Elkhorn Springs and Buffalo Drive Storm Drain System

Supplement#1 to Addendum 1 (Hansen # 23158)

**Re: Elkhorn Springs and Buffalo Drive Storm Drain System – 100% design
submittal**

Re: Elkhorn Springs and Buffalo Storm Drain System
Drainage Report Addendum #1 and 90% Plans (Hansen # 23158)

FIG. 7
of 25
DRAWING NO.
327V283

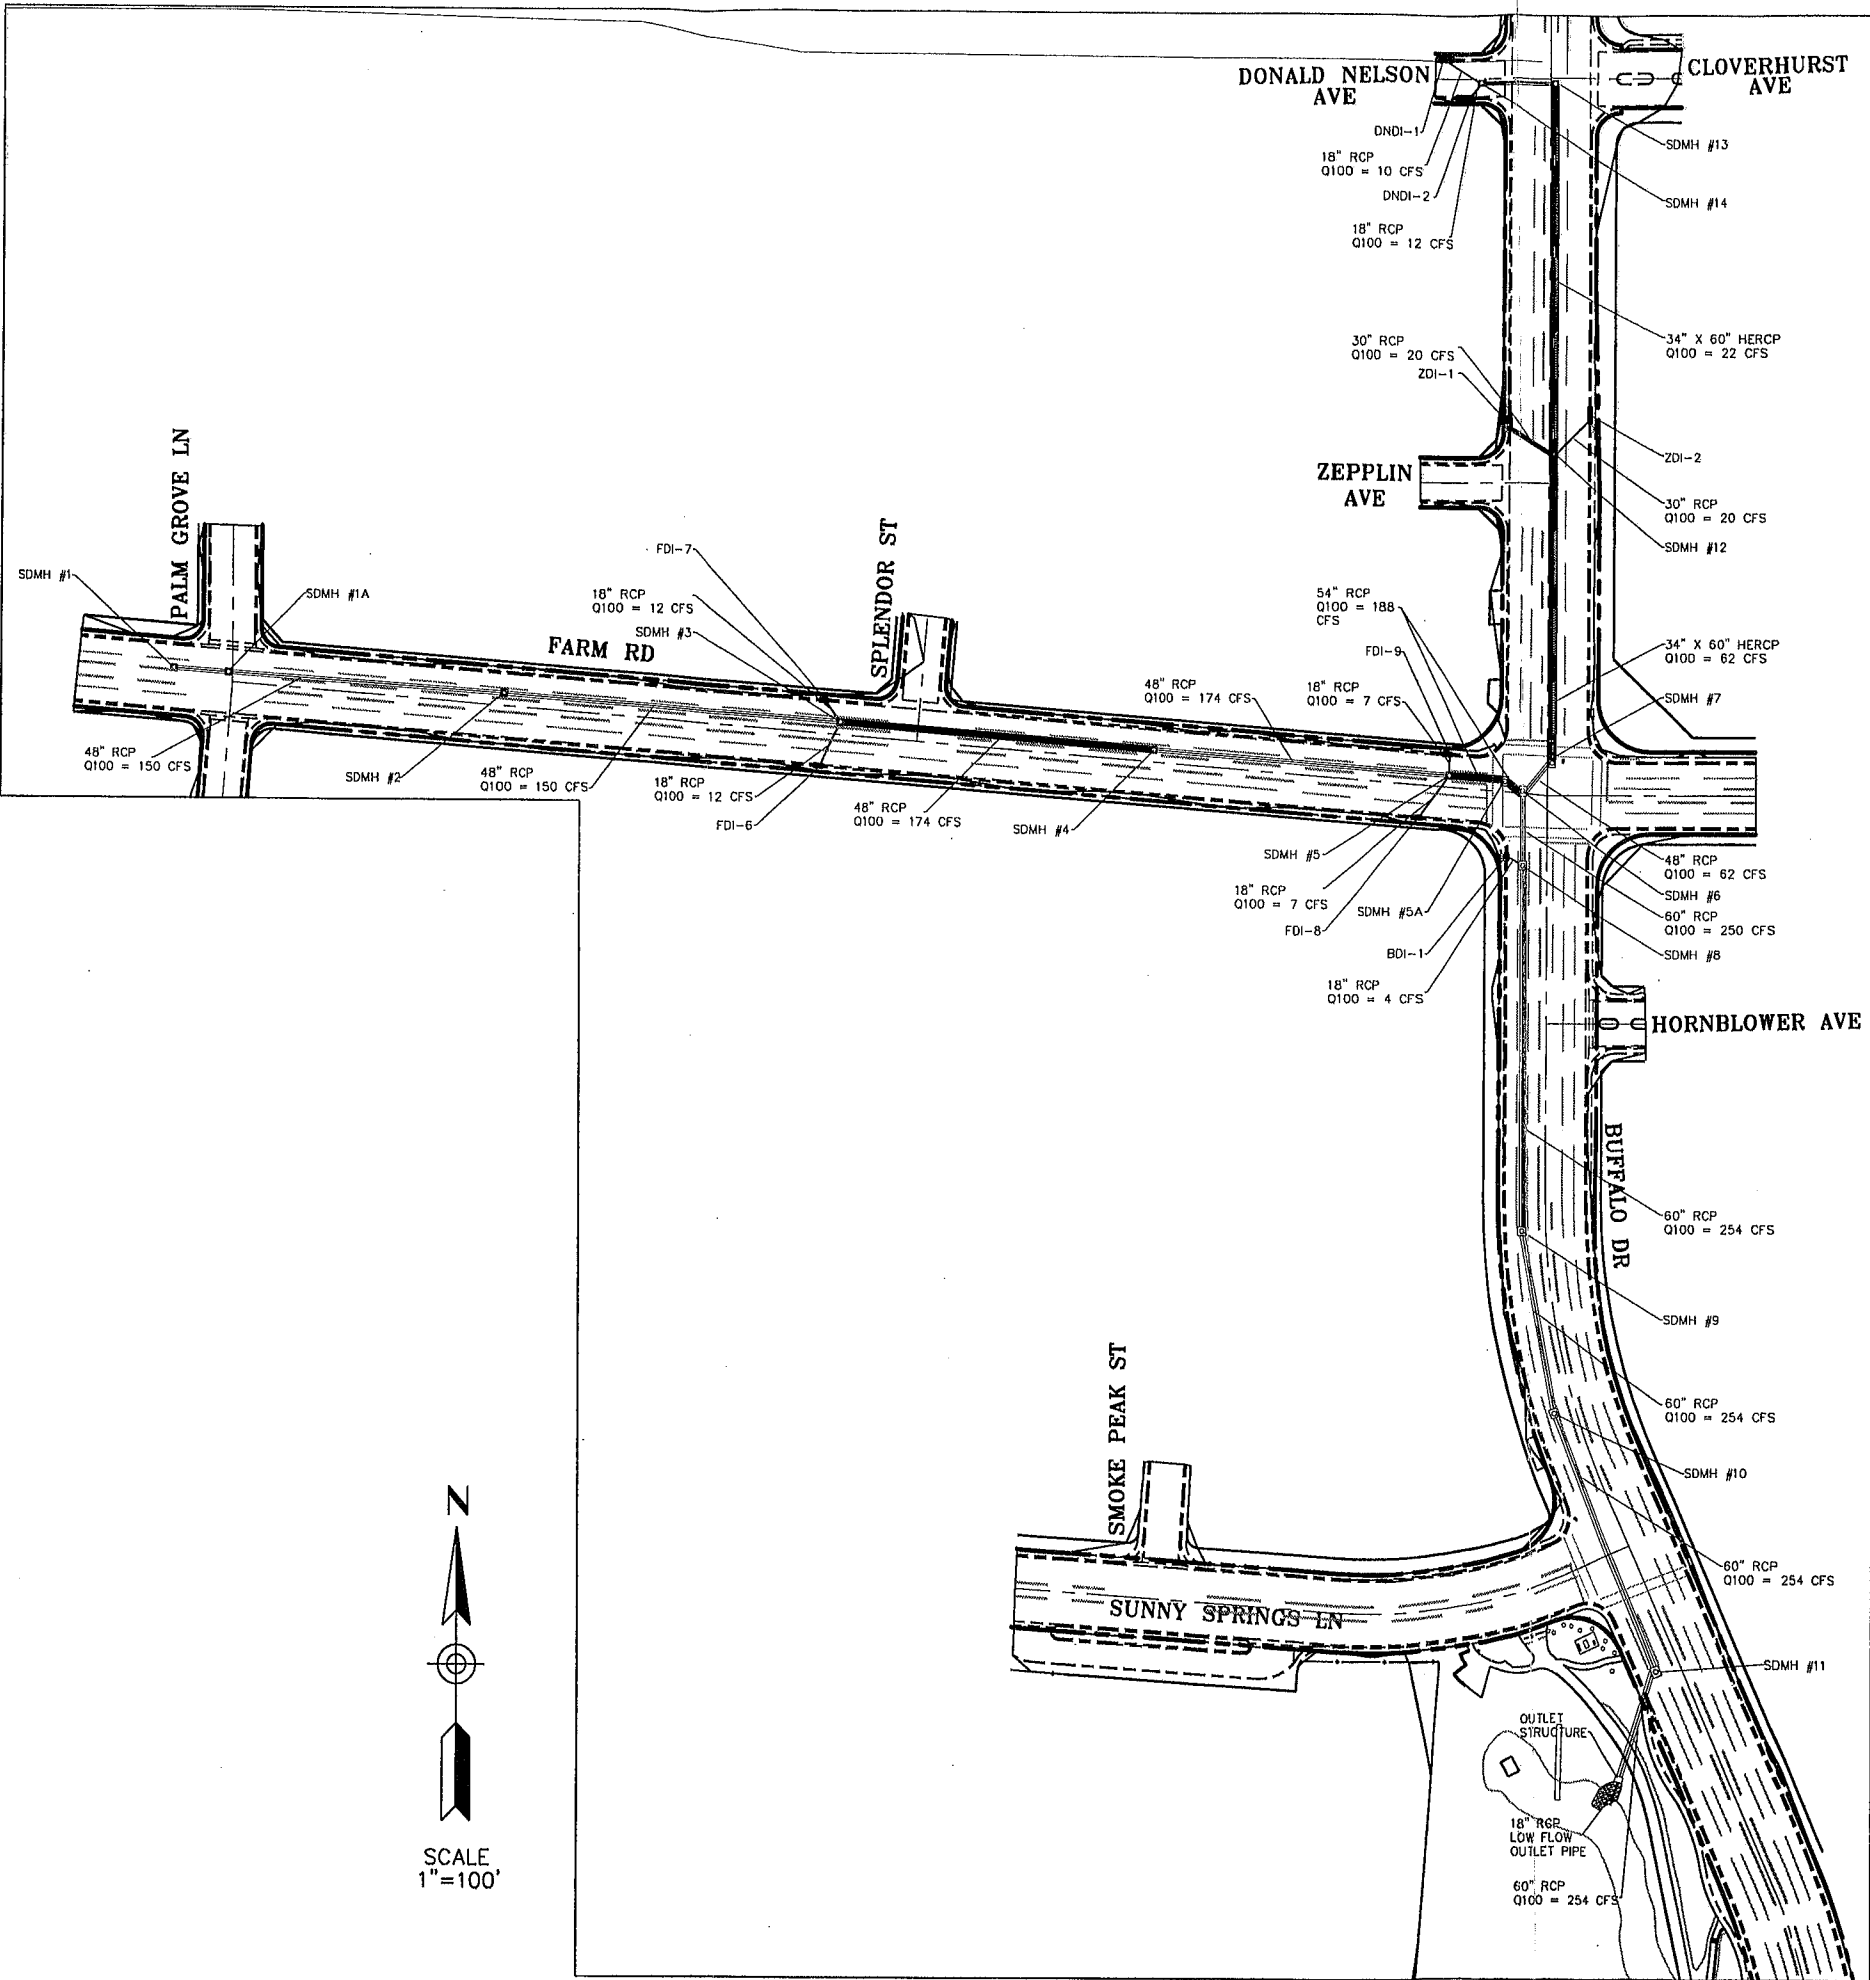
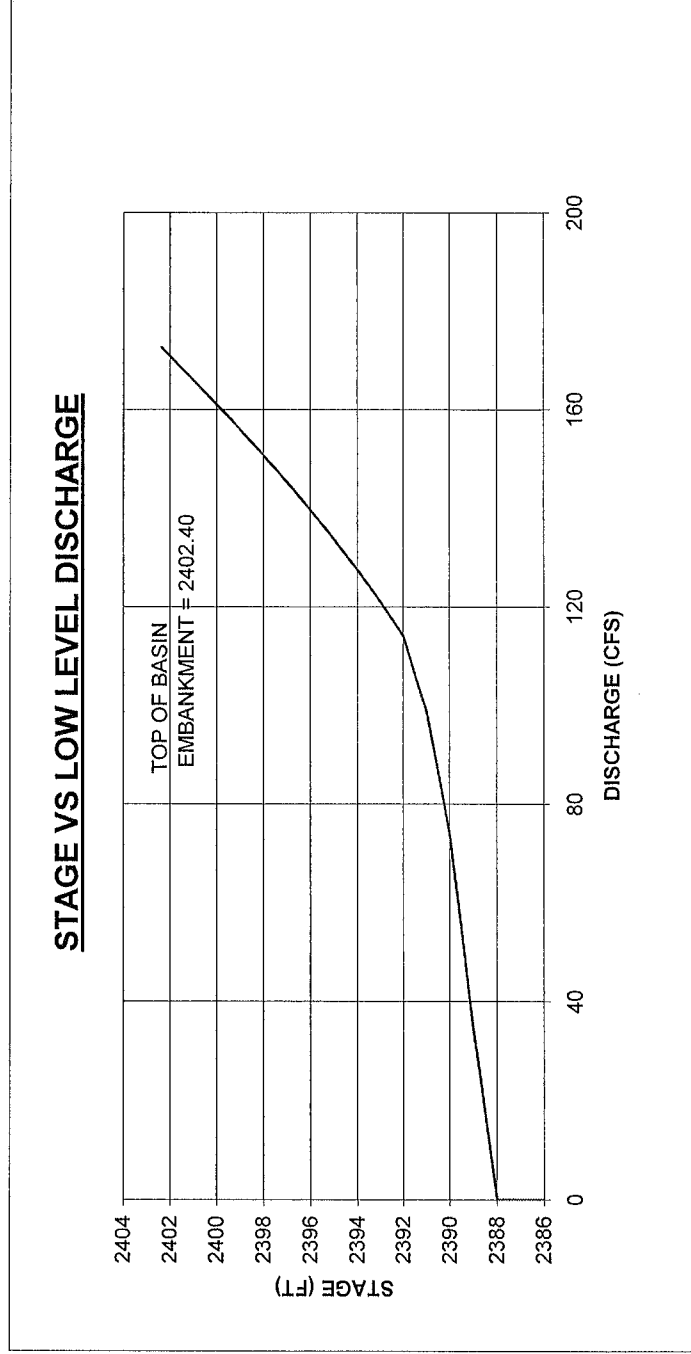
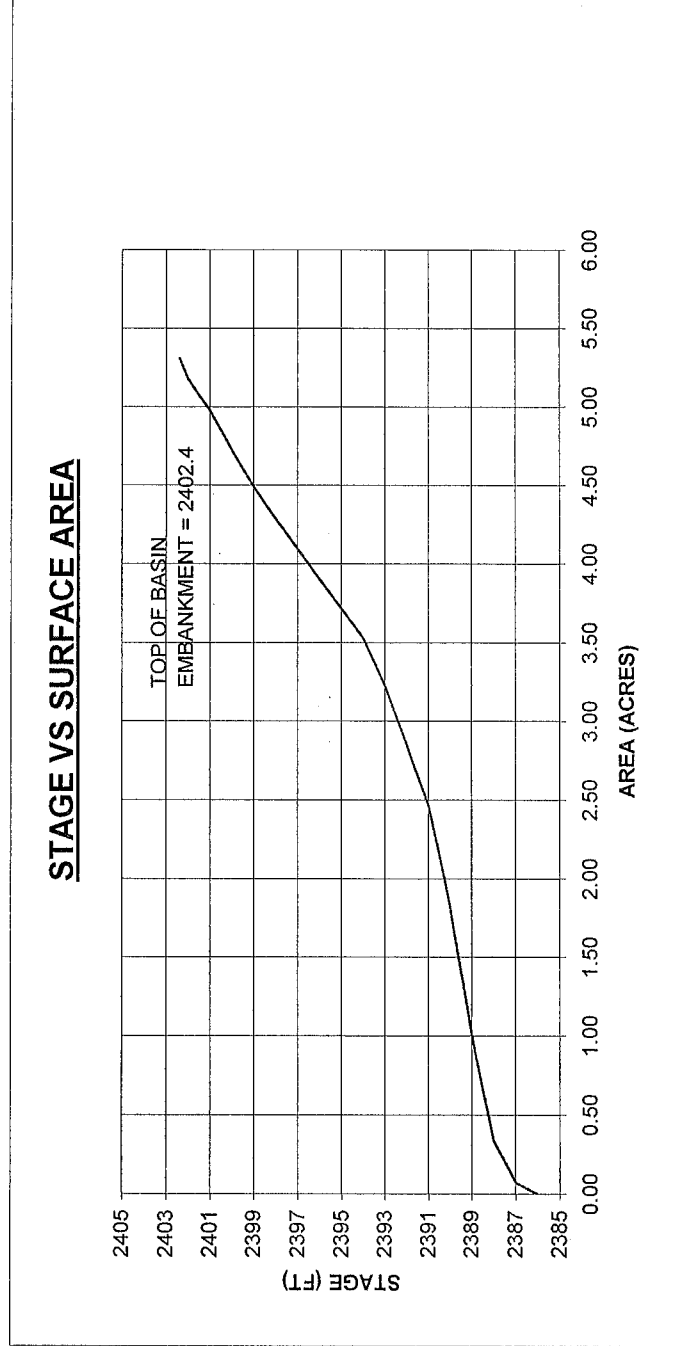
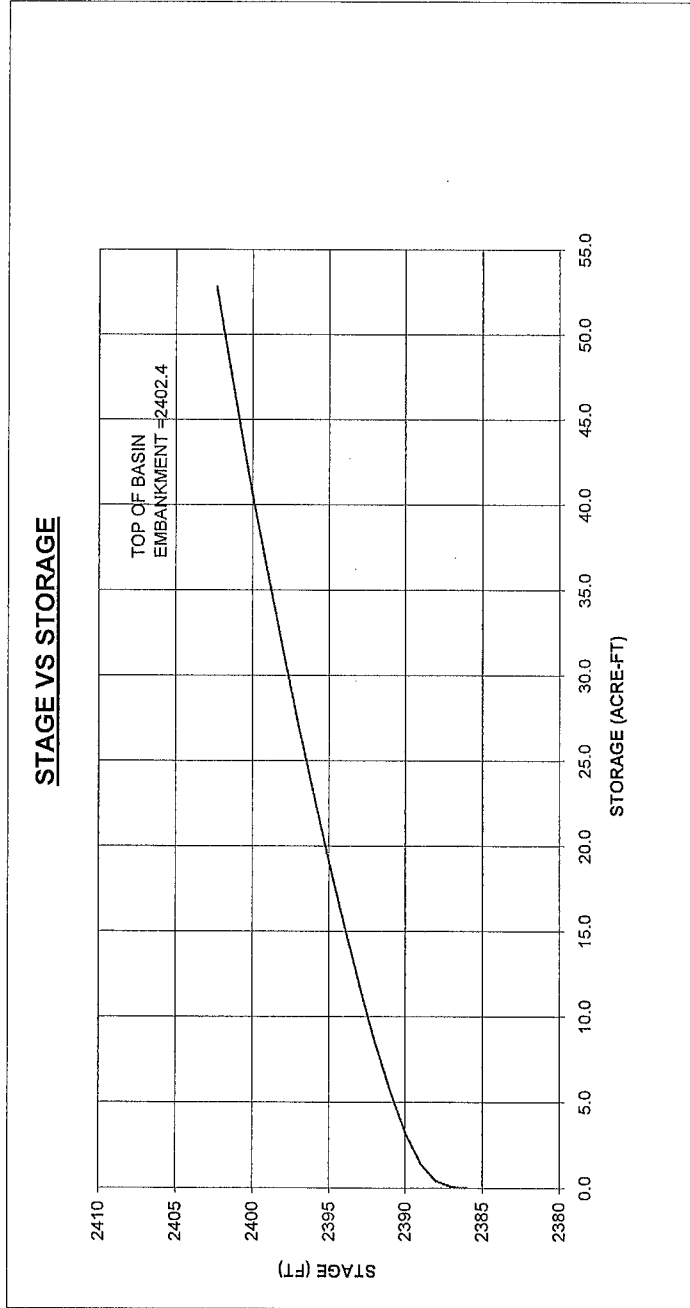
2. Include the storage volume at the spillway elevation (top of embankment) on Sheet G-3. Review the basin topography to verify the elevation of the top of embankment. Sheet SD-4 and Figure 6 shows topographic information above the 2400 elevation. Review and revise the HEC-1 analysis detention basin parameters and provide a revised HEC-1 run that incorporates the higher top of embankment elevations. Revise Figure 6 and the tables and graphs on Sheet G-3 to reflect the new data.

1. The Drainage Study submittal (Standard Form 1) must be stamped and signed by the Civil Engineer.
2. Include the storage volume at the spillway elevation (top of embankment) on Sheet G-3. Review the basin topography to verify the elevation of the top of embankment. Sheet SD-4 and Figure 6 shows topographic information above the 2400 elevation. Review and revise the HEC-1 analysis detention basin parameters and provide a revised HEC-1 run that incorporates the higher top of embankment elevations. Revise Figure 6 and the tables and graphs on Sheet G-3 to reflect the new data.

Response: The storage volume of detention basin is revised. The HEC-1 analysis, figure 6, and tables and graphs on sheet G-4 are revised to reflect new data.
